SB, 1-10DS Lenze I550 VFD + Brake Resistor, 2024-02

SYMPTOM/DESCRIPTION

Replacing the VFD from I510 to I550 with brake resistor solves this.

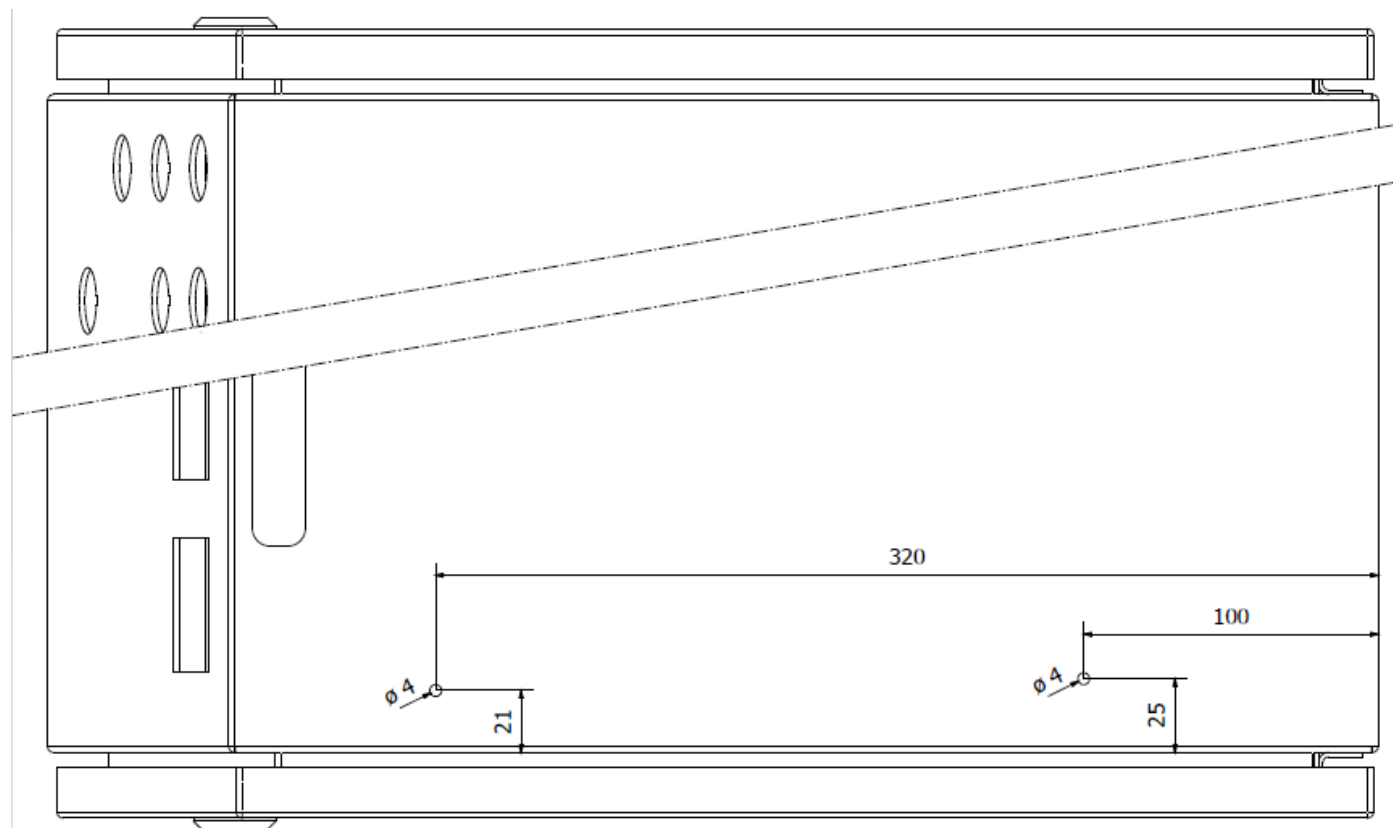
Drill 2 holes of 4mm according the dimensions given here below for mounting the Brake resistor at the inside of the box.

Mount the brake resistor at the newly drilled holes with M4 screws and tighten the M5 screws for the brake resistor.

1-10DS Dual Voltage - Overview E-Box, I510 without Brake Resistor.

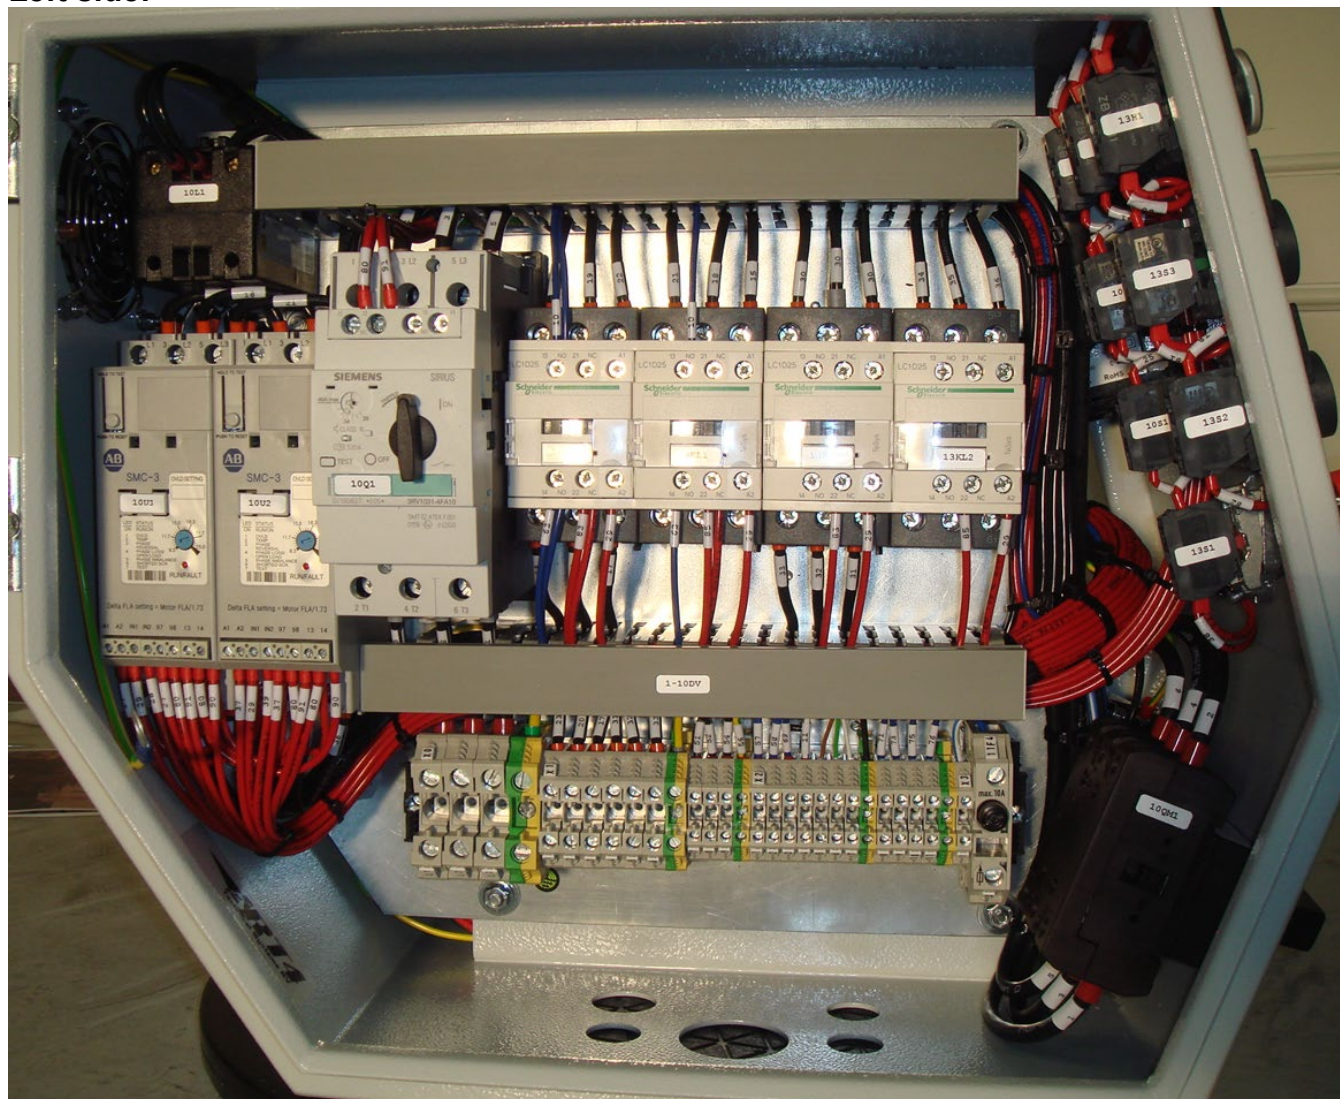
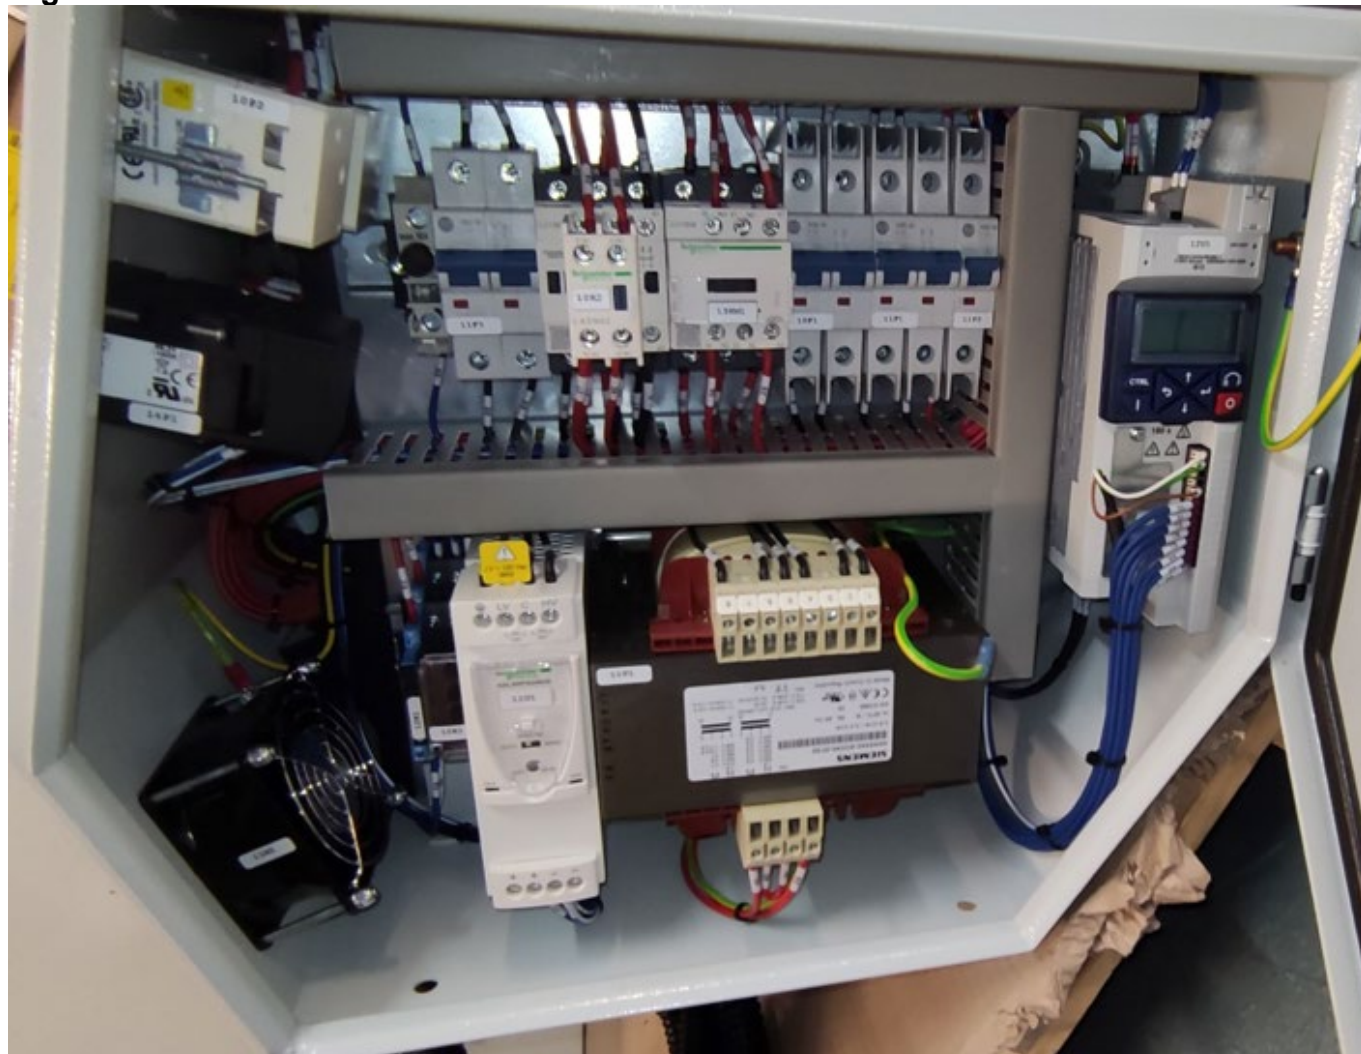
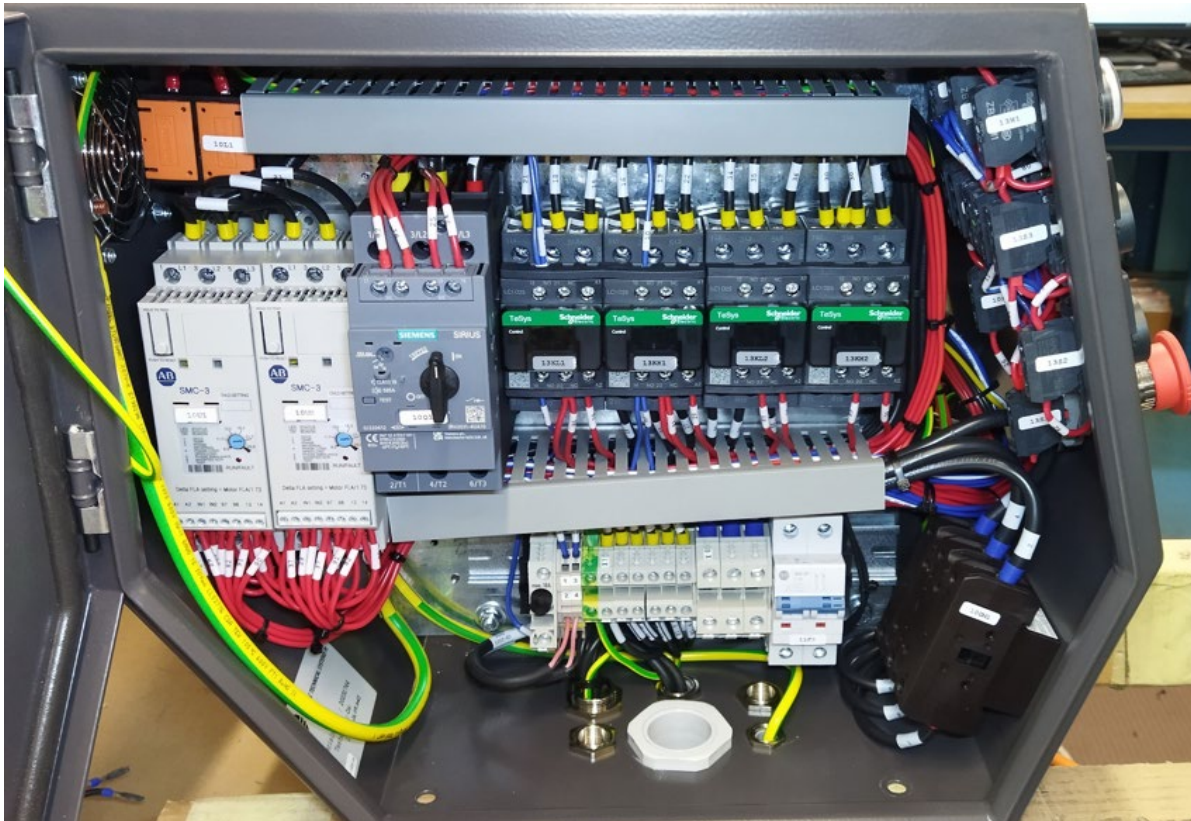
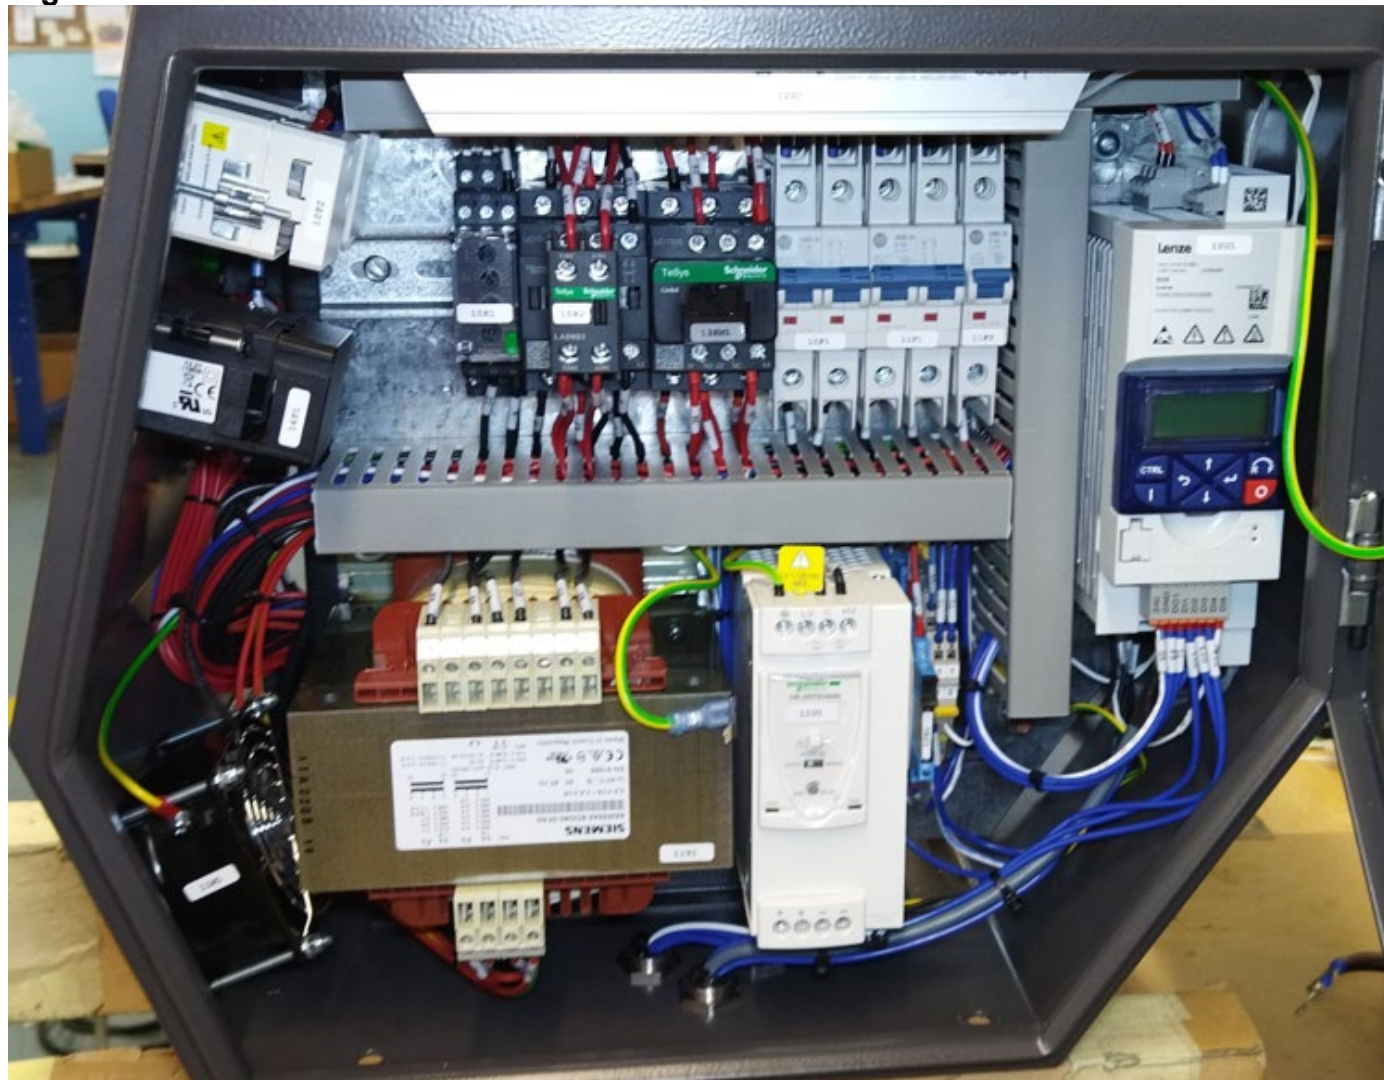
When the 120Hz drive motor is forced to turn due to a downward inclination it turns into a generator and starts feeding energy back to the VFD. The VFD cannot handle the entire generated energy going back and as a result of self-protection it switches off.

1-10DS Dual Voltage - Overview E-Box, I550 with Brake Resistor.

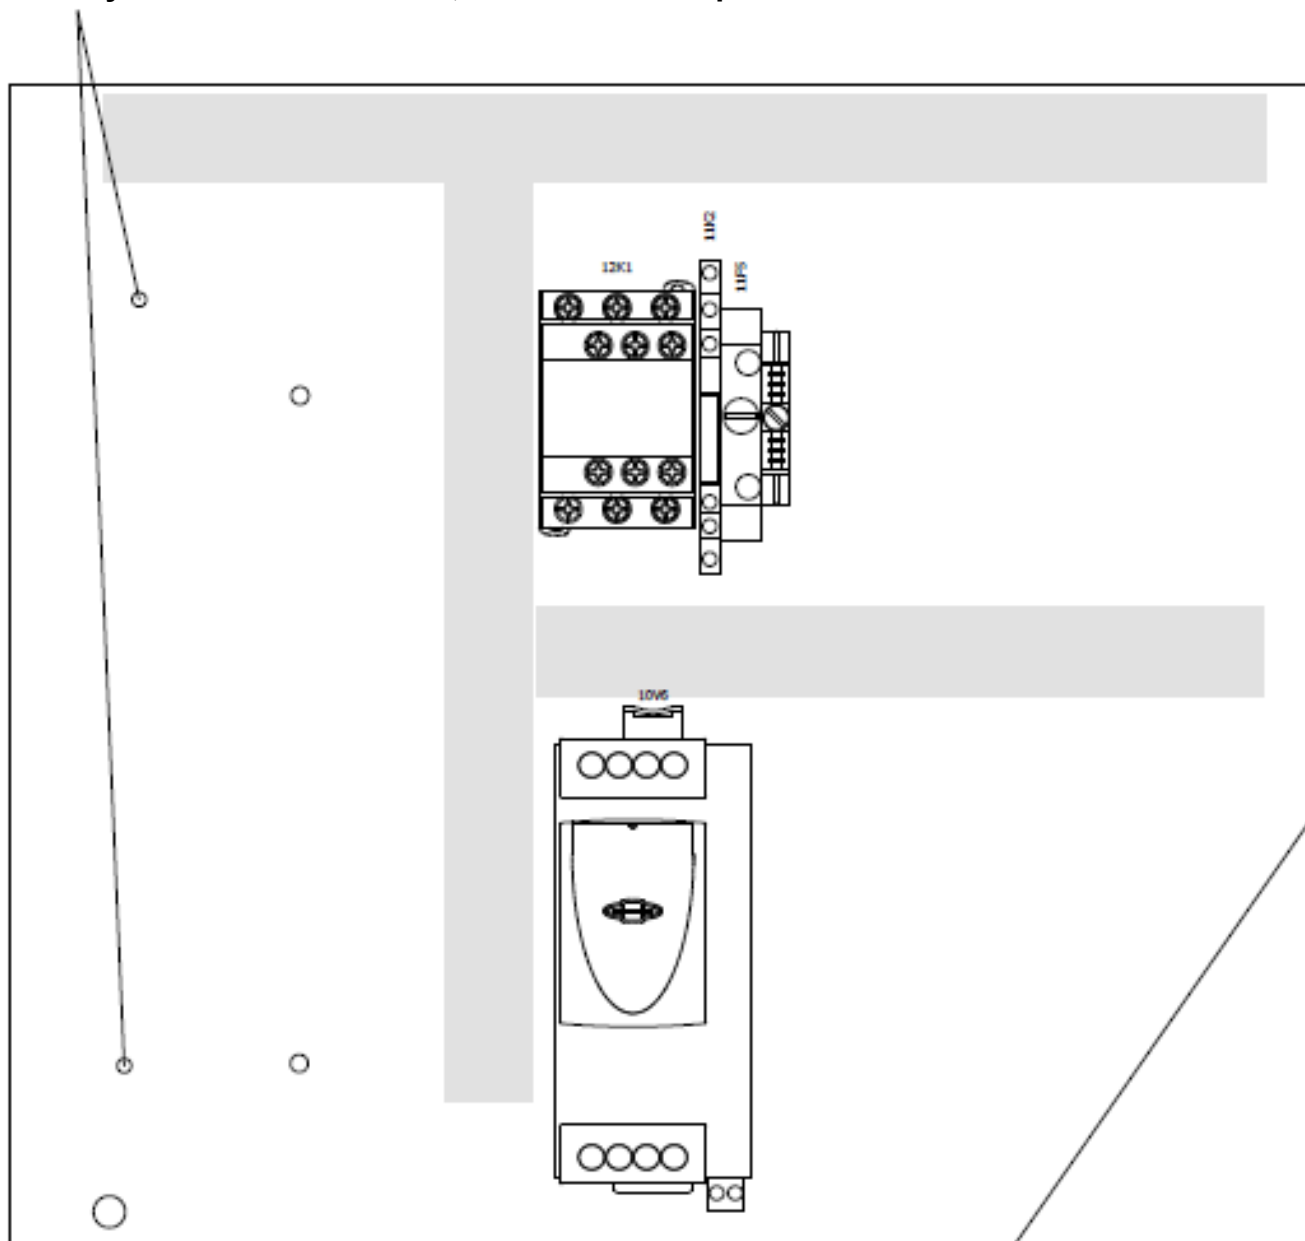
*** BE CAREFUL WHILE DRILLING THE HOLES, THERE ARE OTHER PARTS MOUNTED ON THE BACKSIDE OF THE PANEL!**

Now you drill two holes of 3,3mm and then tap them with M4 thread.
